REV.	DATE	DCN #	DRAWING TREE #
v1	18-APR-2012	E1200002-v1	E1200003-v1
v2	18-OCT-2012	E1200928-v1	E1200929-v1
v3	22-FEB-2013	E1300141-x0	-

CALIFORNIA INSTITUTE OF TECHNOLOGY MASSACHUSETTS INSTITUTE OF TECHNOLOGY		<b>PART NAME</b> ELEVATION SUPPORT WEB	
<b>SYSTEM</b> ADVANCED LIGO	<b>SUB-SYSTEM</b> AOS	<b>DESIGNER</b> M. JACOBSON	06 FEB 2012
<b>CHECKER</b> C. GUIDO	22-FEB-2013	<b>DRFTER</b> E.SANCHEZ	24-FEB-2012
<b>APPROVAL</b> M. JACOBSON	22-FEB-2013	<b>SIZE DWG. NO.</b> B	<b>REV.</b> v3
<b>NEXT ASSY</b> D1101851-1, D1101851-2		SCALE: 1:2	PROJECTION:
			SHEET 1 OF 1

D1200265\_ELEVATION SUPPORT WEB, PART PDM REV: X-006, DRAWING PDM REV: X-009

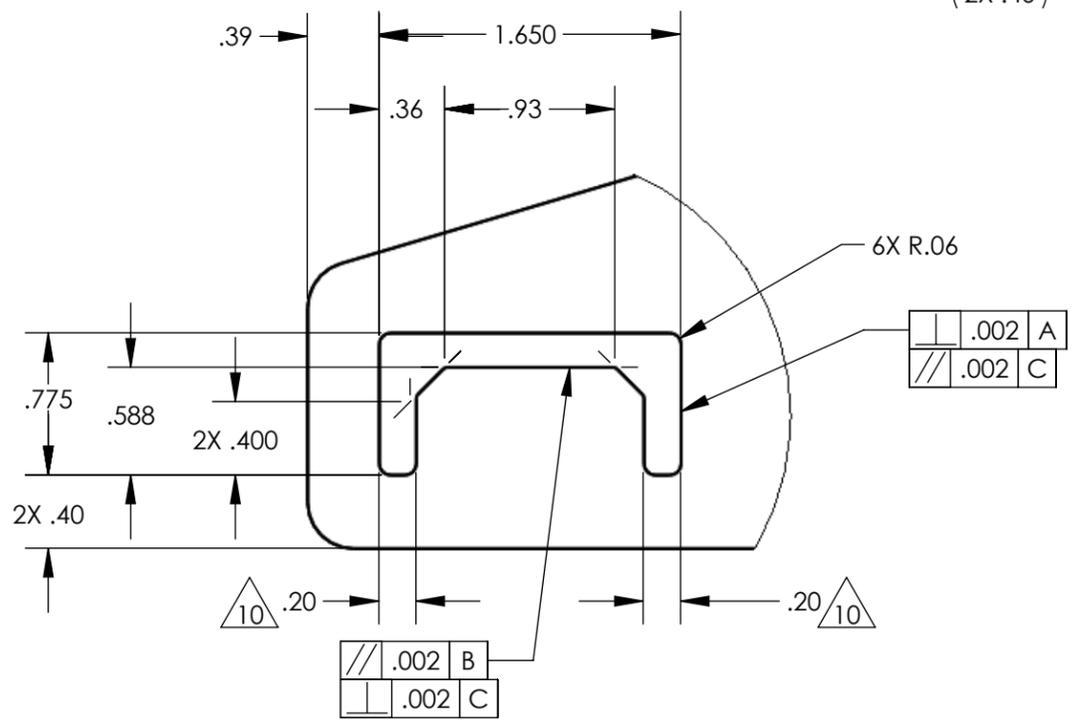
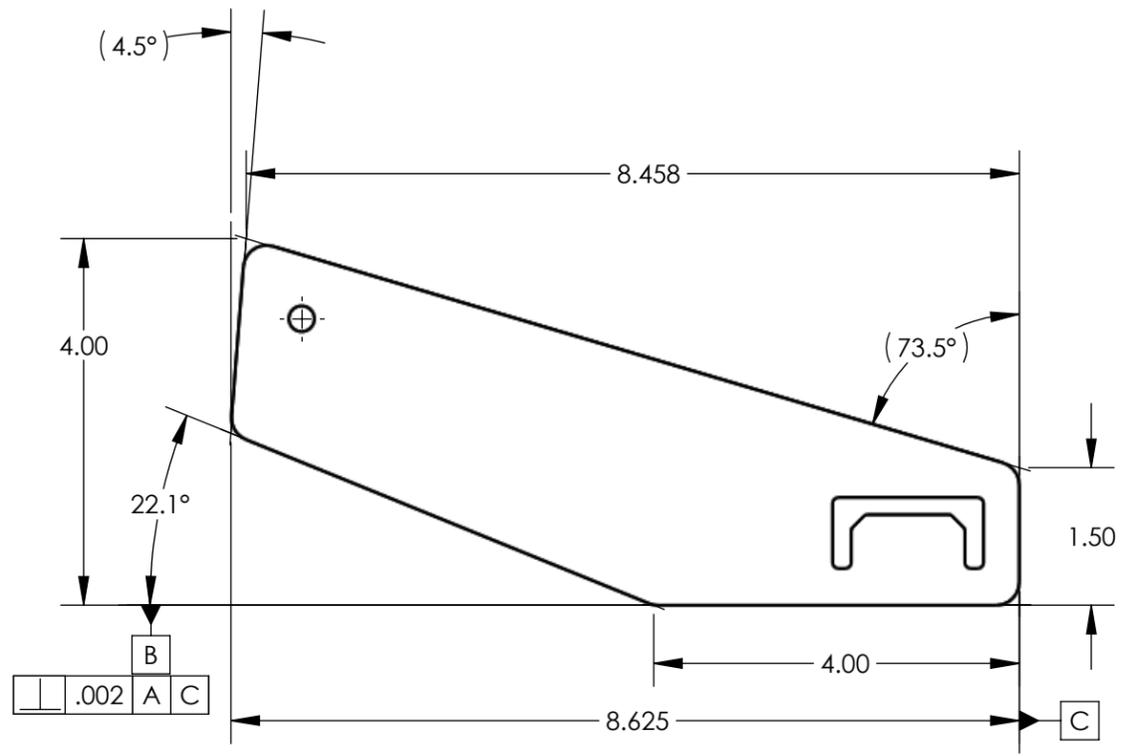
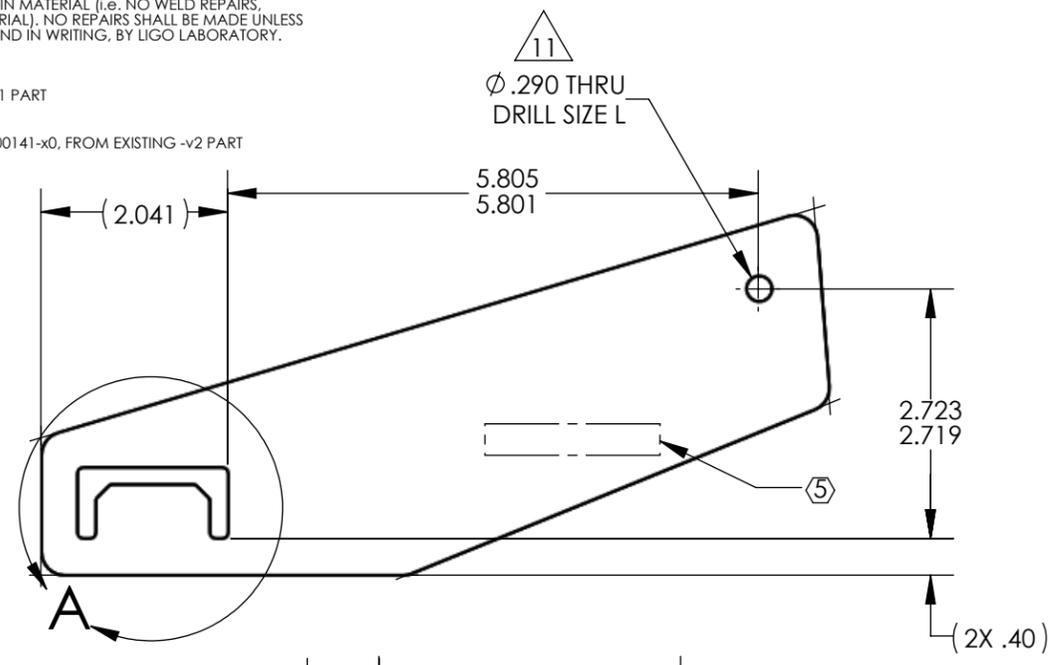
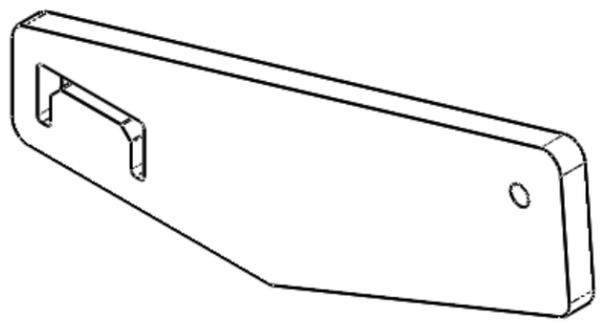
11. CHANGES PER DCN E1300141-x0, FROM EXISTING -v2 PART
